Access Compliance Report Public Rights-of-Way (Pedestrian Signals)

Main Street: CERRITOS_AVE Cross Street: GILBERT_ST Location: NW

ADA ID: SGRK210923133204 Signal Type: One Push Button-Non APS Overall Compliance: No Severity Scores: BTN 1: 25 BTN 2: N/A No BTN: N/A

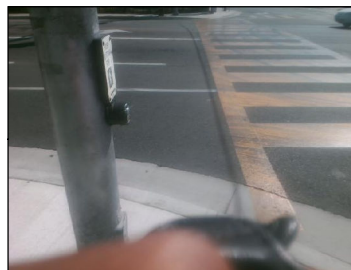
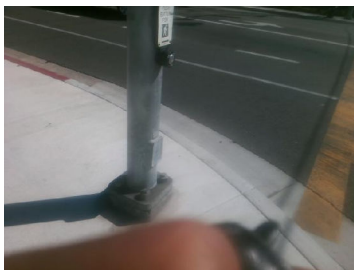
OC Std/PROW: R404.2, R404.3

Possible Solutions: Remove and Replace Clear Space.
